# Work Order ID 113973

Item Name: Crosstube Turning Detail

<b>DART AEROSPACE LTD</b>	<b>Work Order:</b> 113973
<b>Description:</b> Crosstube Assembly (412 High Aft)	<b>Part Number:</b> D412-664-243
<b>Inspection Dwg:</b> D412-664-243 Rev: E	<b>Page 1 of 2</b>

DRAWING NO. D412-664-243	TITLE CROSSTUBE ASSEMBLY (412 HI AFT)	REV. E	DART AEROSPACE LTD ENGINEERING ORDER		D.E.O. NO. D412-664-243-E-4	SHEET NO. SHEET 1 OF 3	SCALE NTS
DRAWN 97	CHECKED A	MFG. APPR. A	APPROVED MP		DE APPR. MP		
DATE 12.08.21	DATE 12.08.30	DATE 12.08.30	DATE 12/8/30		DATE 12.08.30

D412-664-603  
BENT TUBE

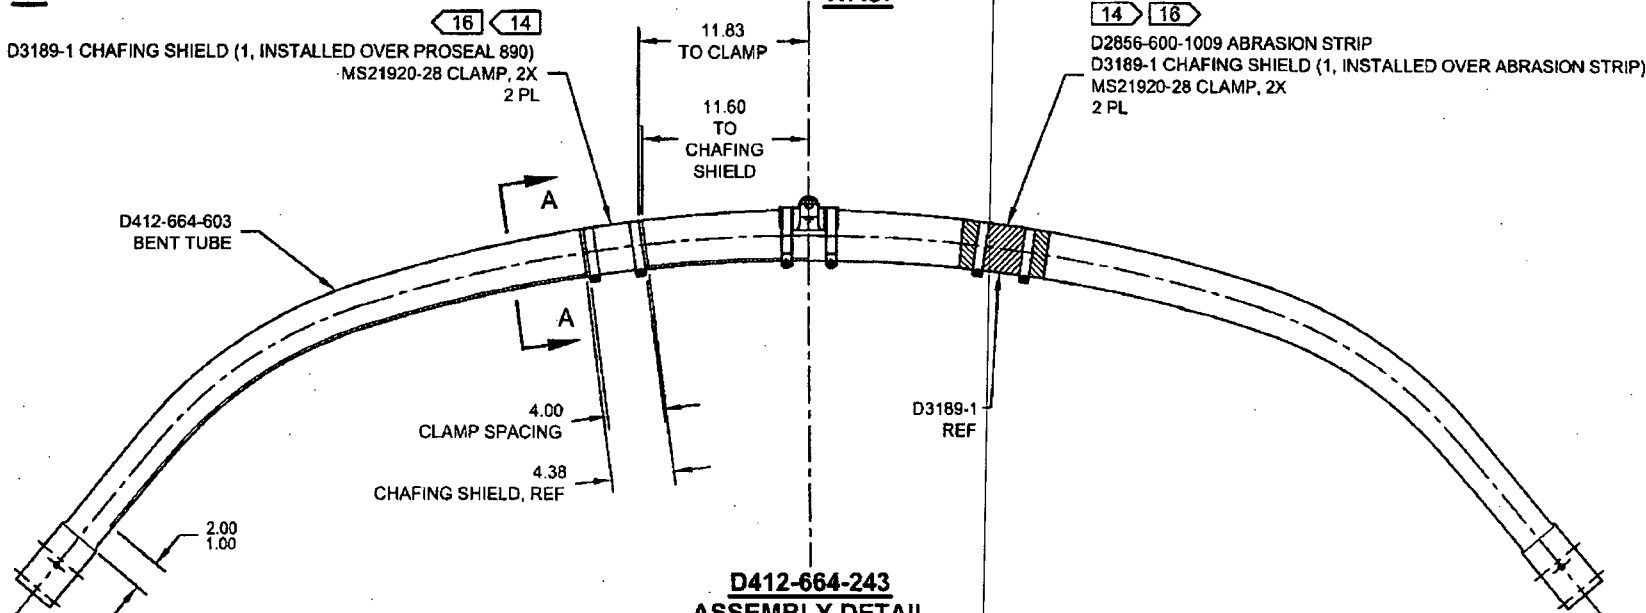
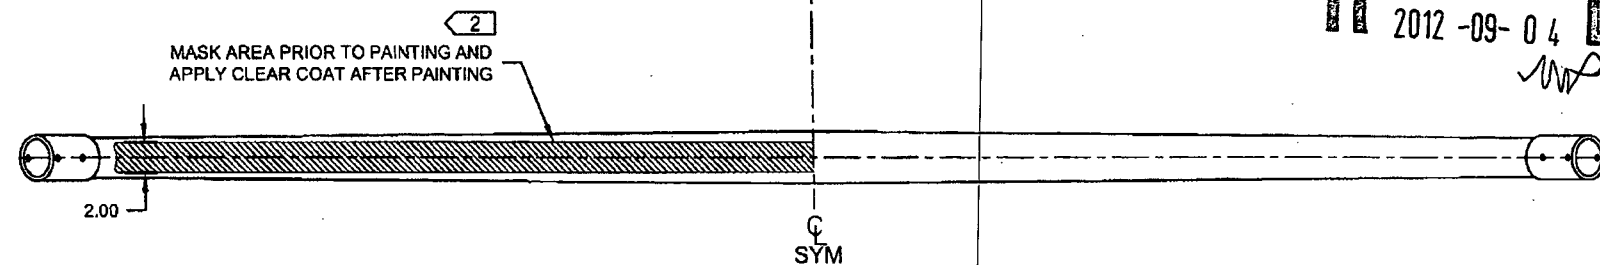
REMOVED ABRASION STRIP IN FAVOR OF A THIN LAYER OF PROSEAL 890. UPDATE INSTALLATION OF CHAFING SHIELDS AND REDUCE TORQUE TO 40-50 IN-LBS. THIS ENGINEERING ORDER SUPERCEDES DEO D412-664-243-E-1.

D3189-1 CHAFING SHIELD (1, INSTALLED OVER PROSEAL 890)  
MS21920-28 CLAMP, 2X  
2 PL

D2856-600-1009 ABRASION STRIP  
D3189-1 CHAFING SHIELD (1, INSTALLED OVER ABRASION STRIP)  
MS21920-28 CLAMP, 2X  
2 PL

**SECTION A-A**  
CHAFING SHIELD DETAIL  
VIEW ROTATED, NOT TO SCALE

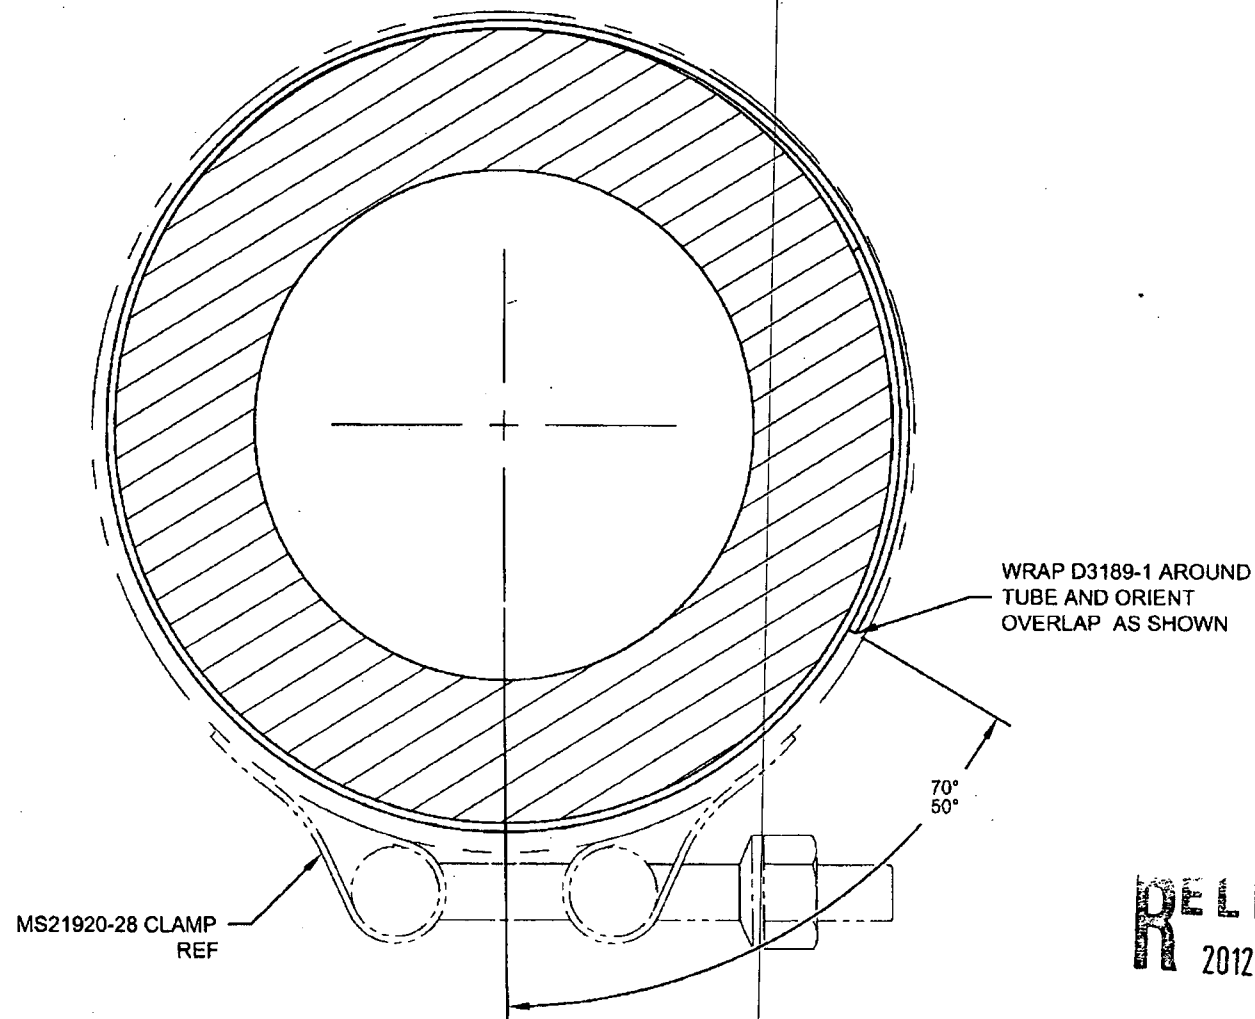
- 2) FINISH: CHEMICAL CONVERSION COAT PER DART QSI 005 4.1  
PRIME INSIDE AND OUTSIDE PER DART QSI 005 4.2  
MASK UNDERSIDE OF CROSSTUBE AS SHOWN (HATCHED AREA)  
PAINT OUTSIDE PER DART QSI 005 4.2  
AFTER PAINTING, APPLY CLEAR COAT ON HATCHED AREA
- 14) APPLY A THIN COAT OF PROSEAL 890 ON INSIDE CONCAVE SURFACE OF D3189-1 CHAFING SHIELD AND LET CURE PER MANUFACTURER'S INSTRUCTIONS. INSTALL PROSEALED D3189-1 CHAFING SHIELD ONTO CROSSTUBE BY APPLYING A THIN COAT OF PROSEAL 890 ONTO CROSSTUBE. BE SURE TO ELIMINATE ANY AIR GAPS.
- 16) TORQUE CLAMPS ON D2896-1 SUPPORT 80 TO 100 IN-LB. **TORQUE CLAMPS ON D3189-1 CHAFING SHIELD 40 TO 50 IN-LB.**  
ENSURE AT LEAST 1.5 THREADS SHOWING IN SAFETY AND THAT NUT HAS NOT BOTTOMED-OUT AFTER TORQUING.
